**AN AMENDMENT TO THE
MASTER DRAINAGE DEVELOPMENT PLAN
FOR
WATERVIEW**

WATERVIEW NORTH

EL PASO COUNTY, COLORADO

October 2020

PROJECT: WATERVIEW NORTH
SHEET TITLE: PRE-DEVELOPMENT BASIN MAP
FROM n/a TO n/a
JOB NO. 02-19-05 SHEET 2 OF 3

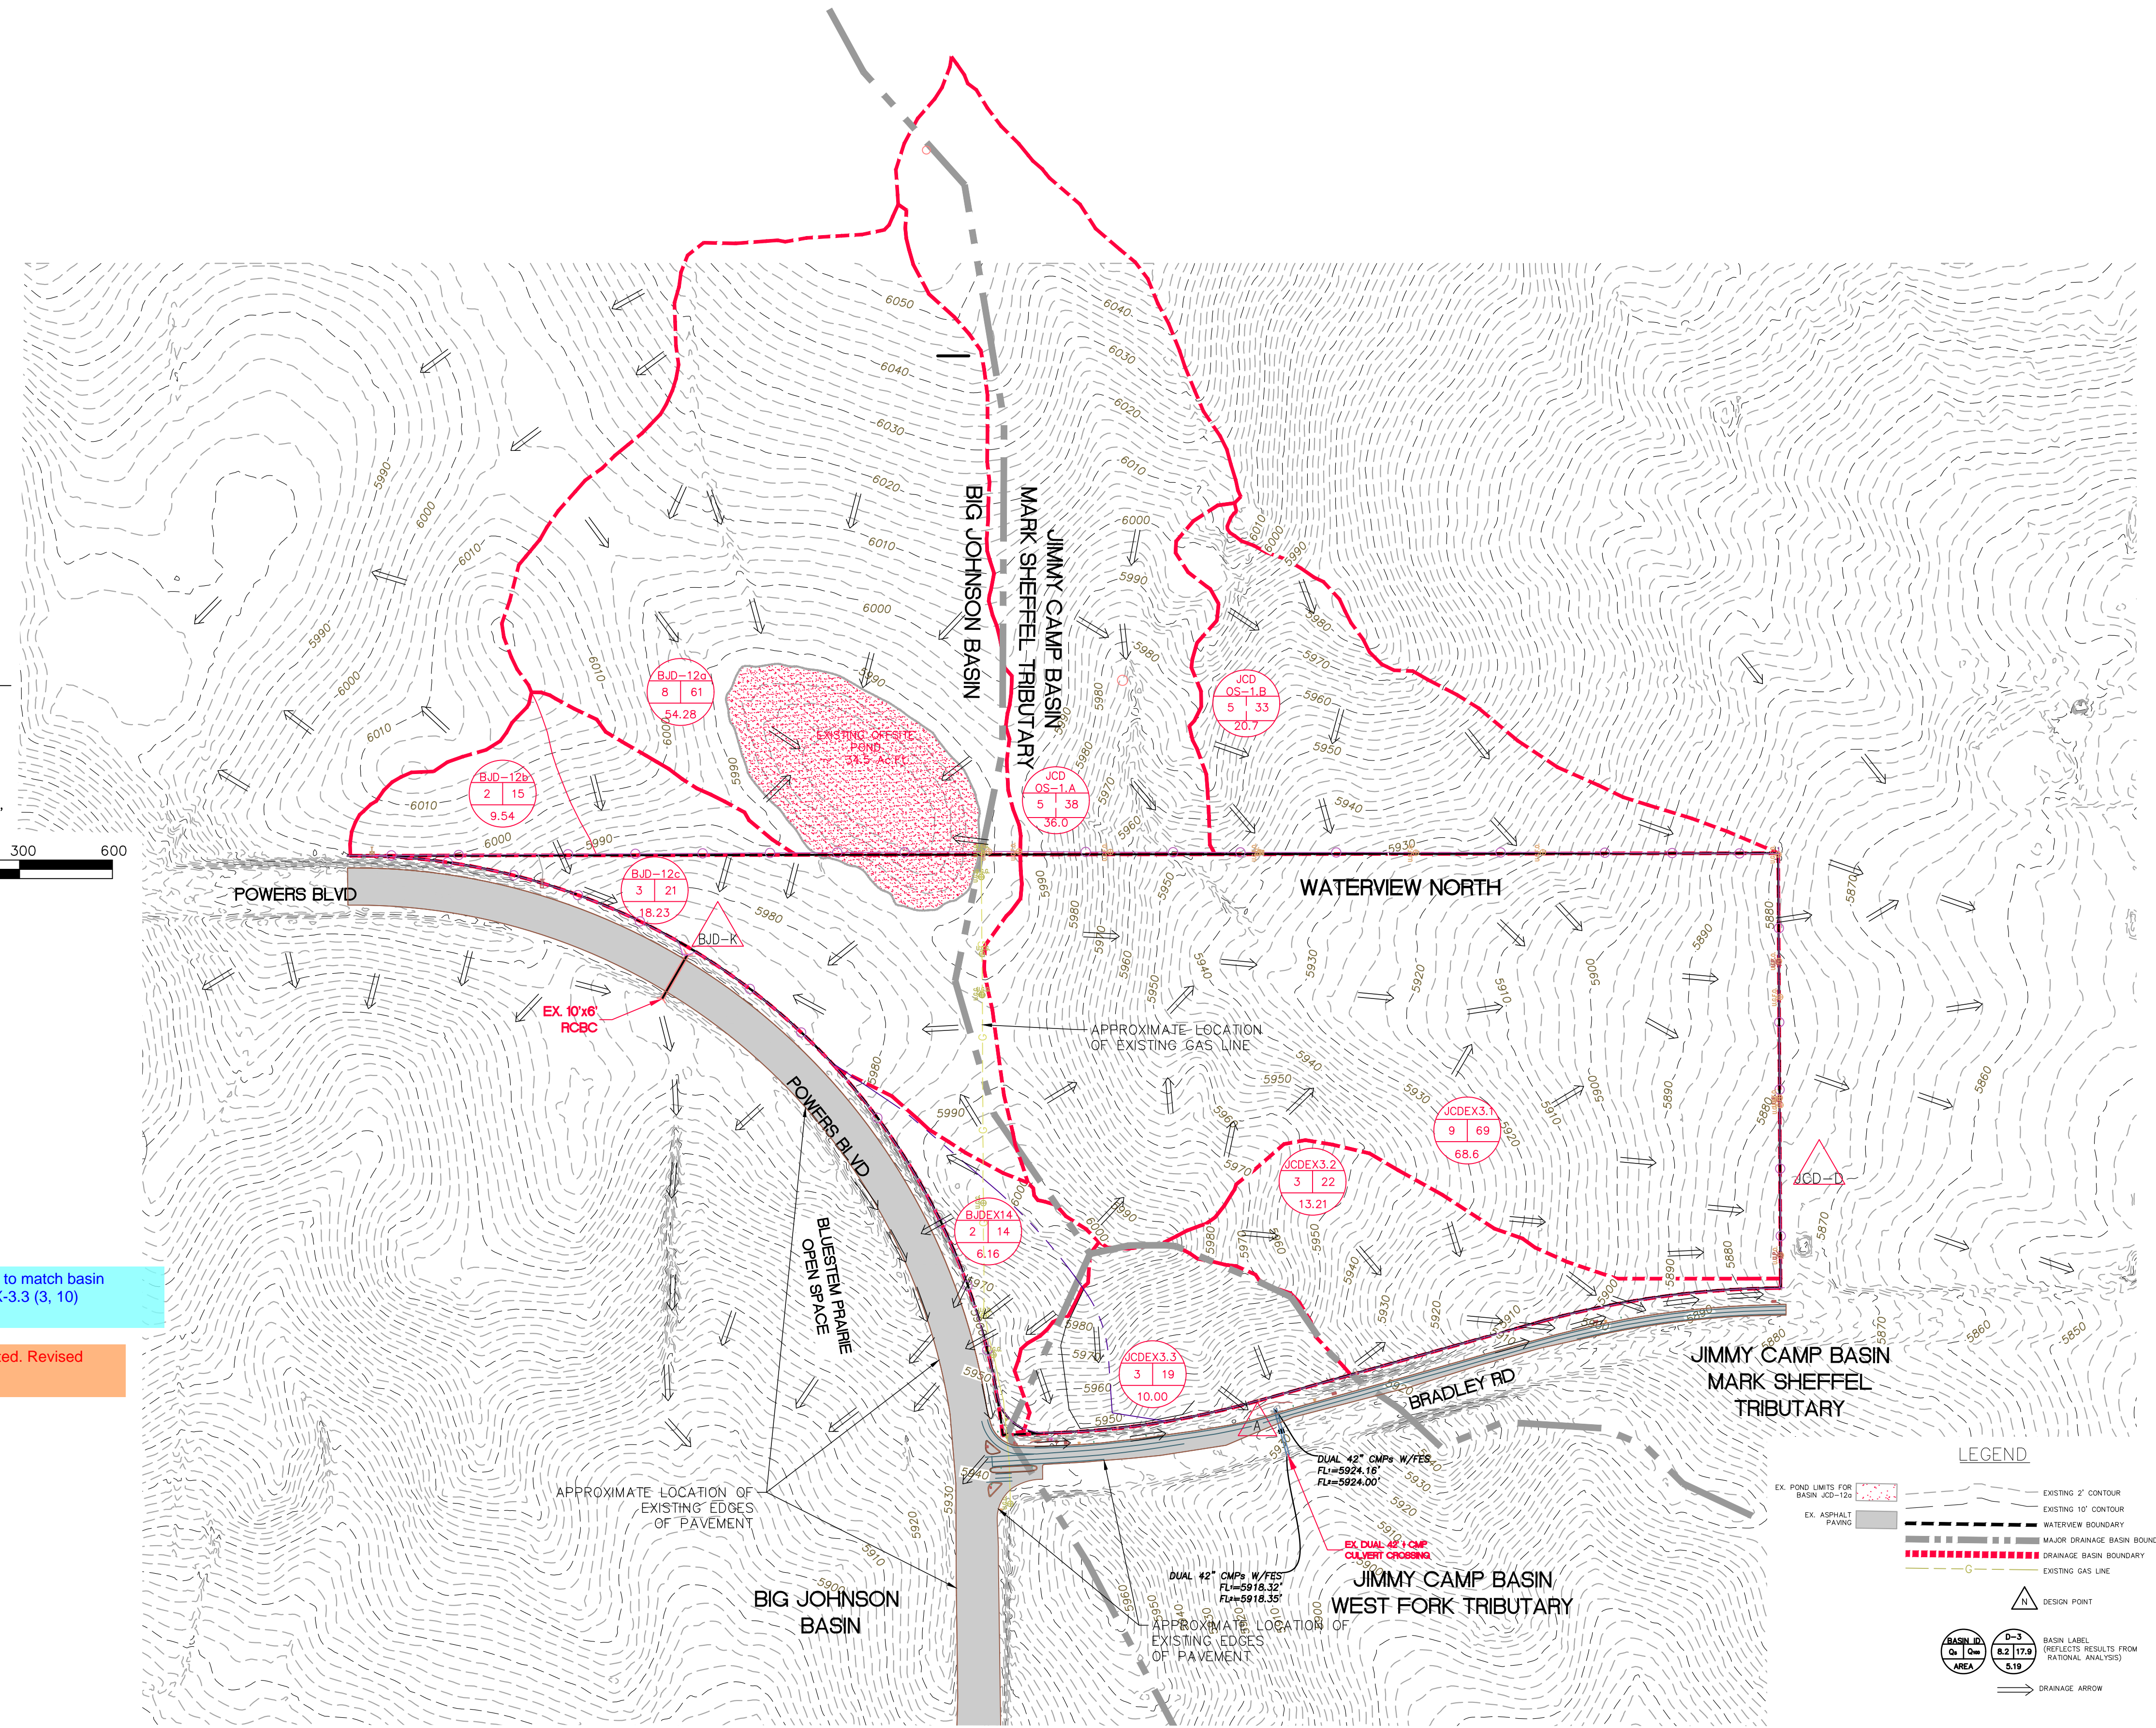
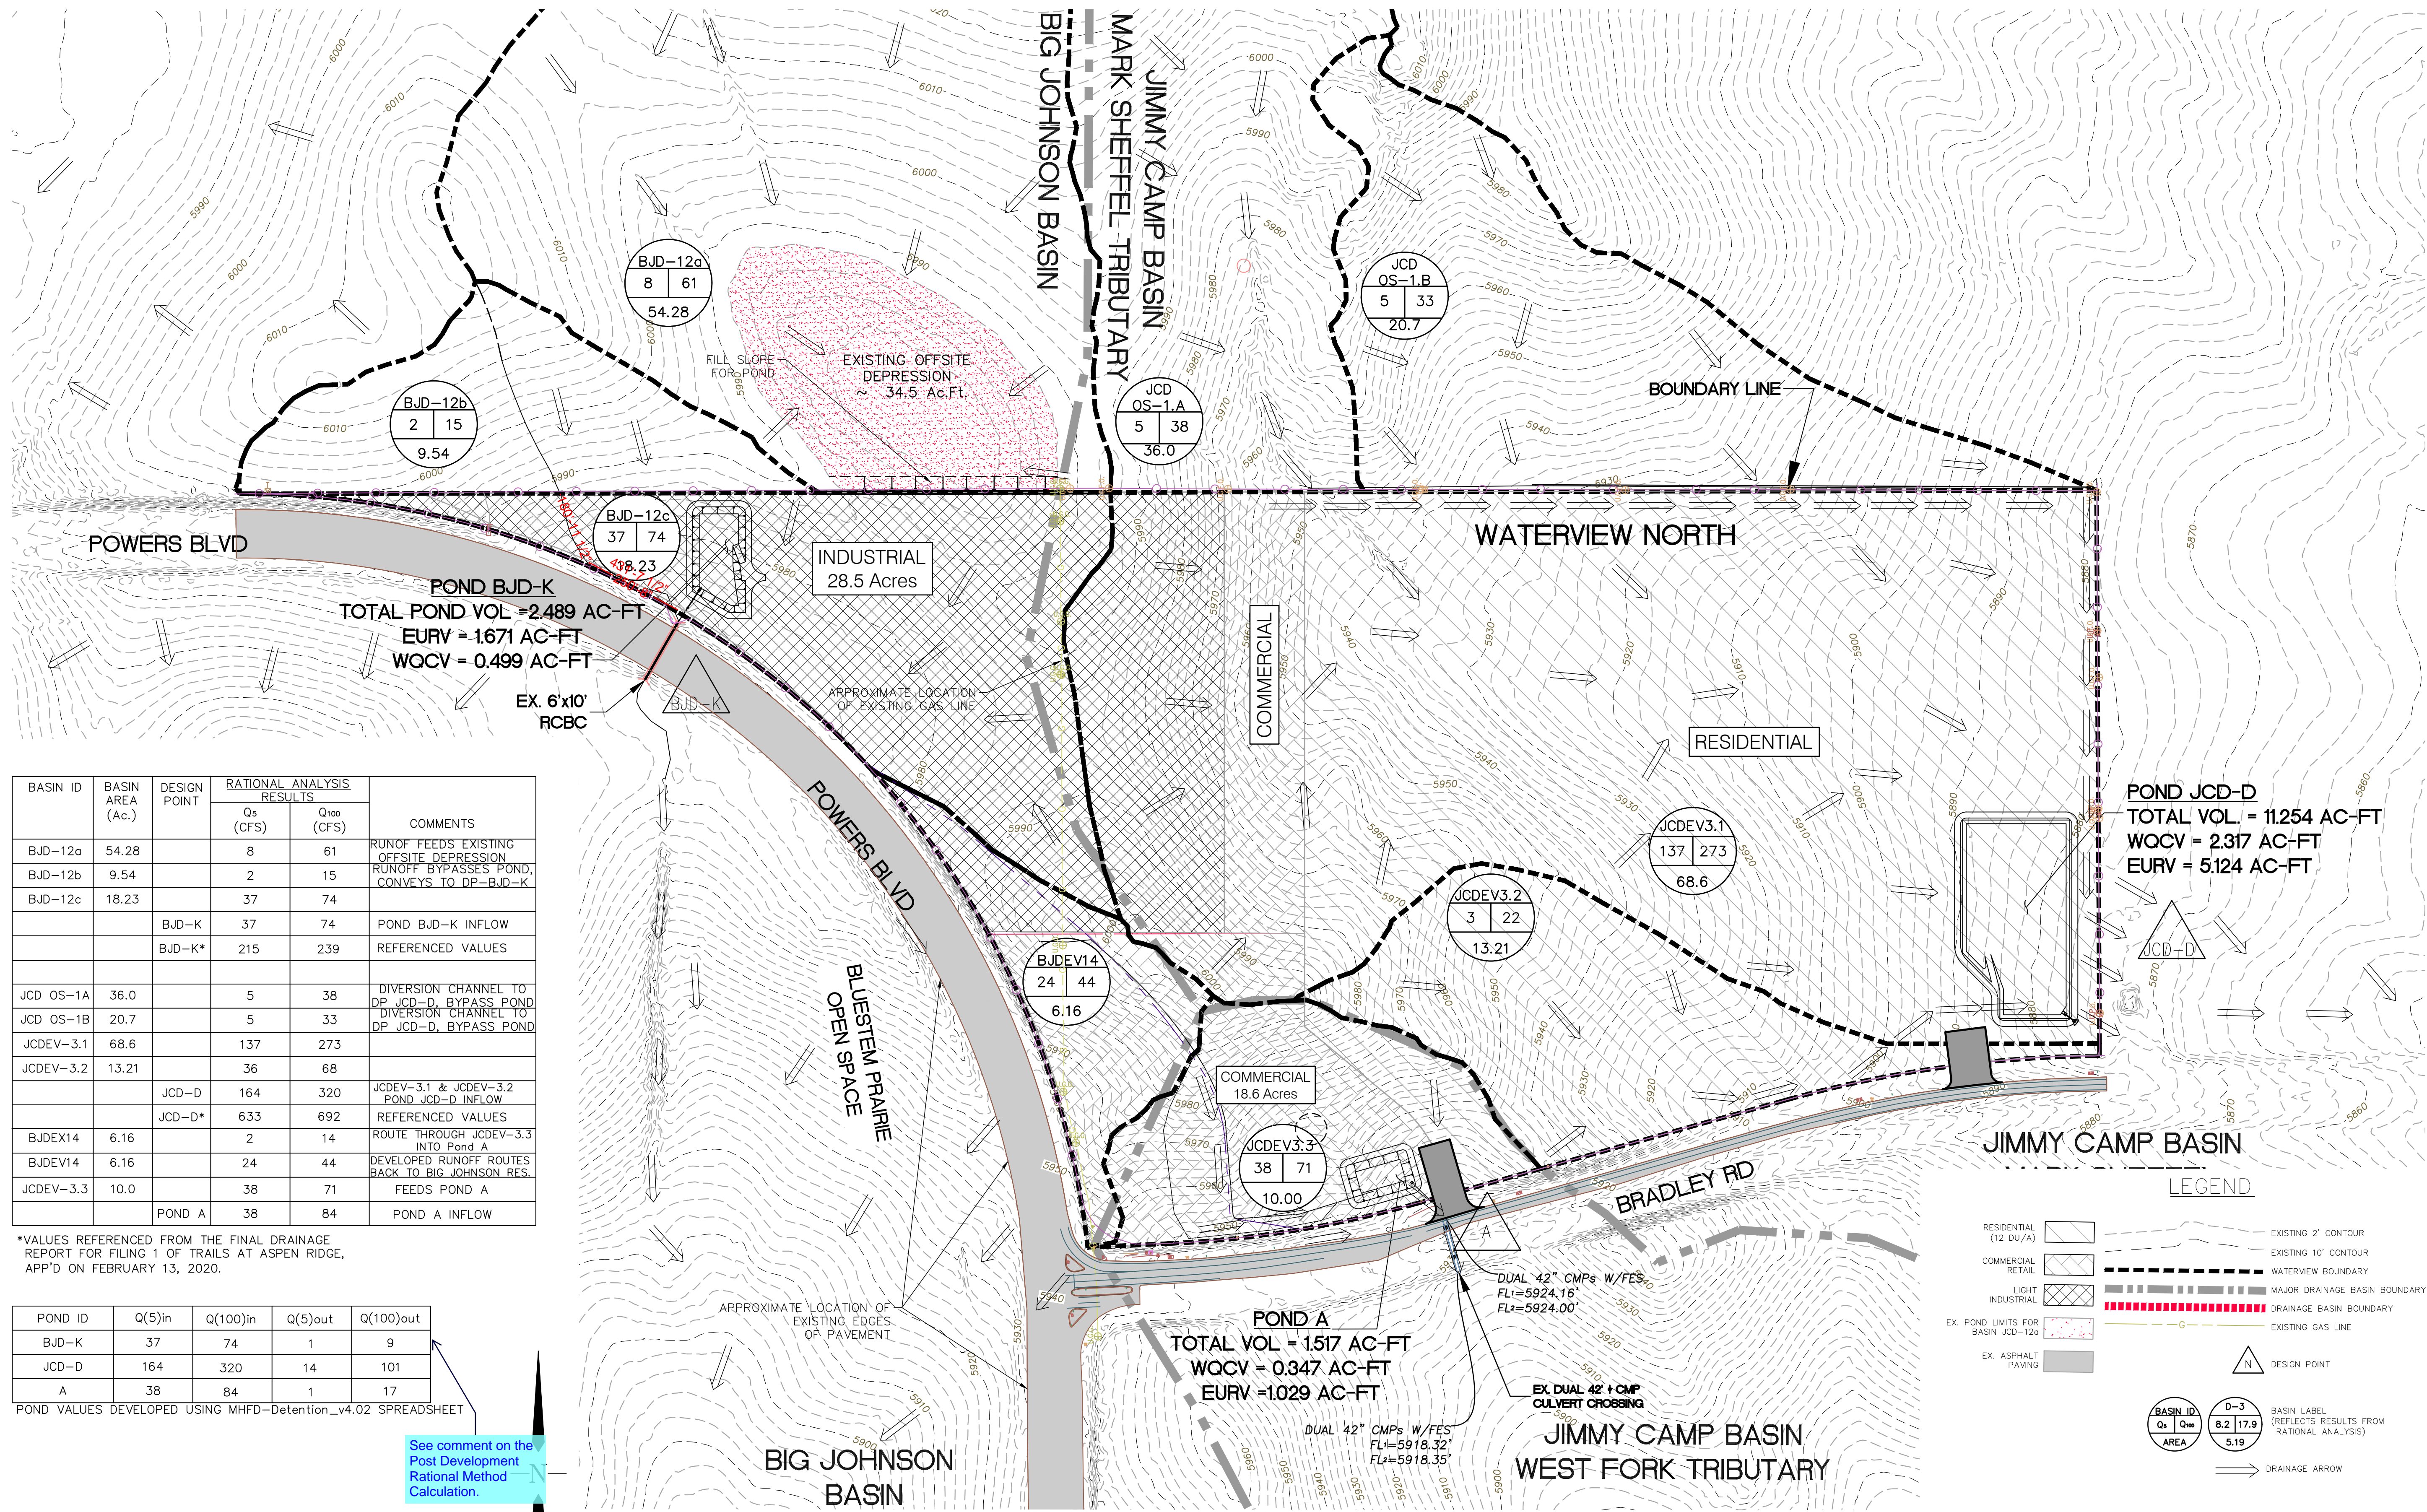
Revise to match basin JCDEX-3.3 (3, 10)

DSE Response: Noted. Revised accordingly.
